Product Discontinuation Notice

June, 2015

Tadiran Batteries has decided to discontinue the production of our "BEL" size batteries.

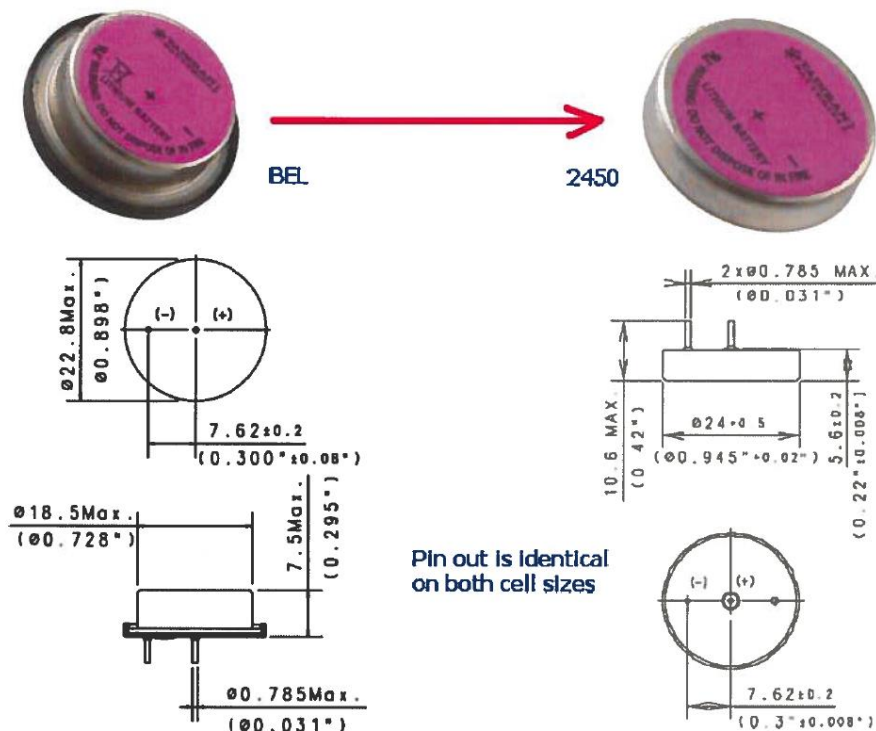
Models; SL-840, TL-4986, TLH-4986 and the TL-5186.

The TL-2450 is 2mm larger in diameter, but 2mm less in height. The pin out is identical to the BEL cell and the capacity is significantly higher.

The replacement we are recommending is our TL-2450 battery and the high temperature version, TLH-2450. Data sheets are available on our web site.
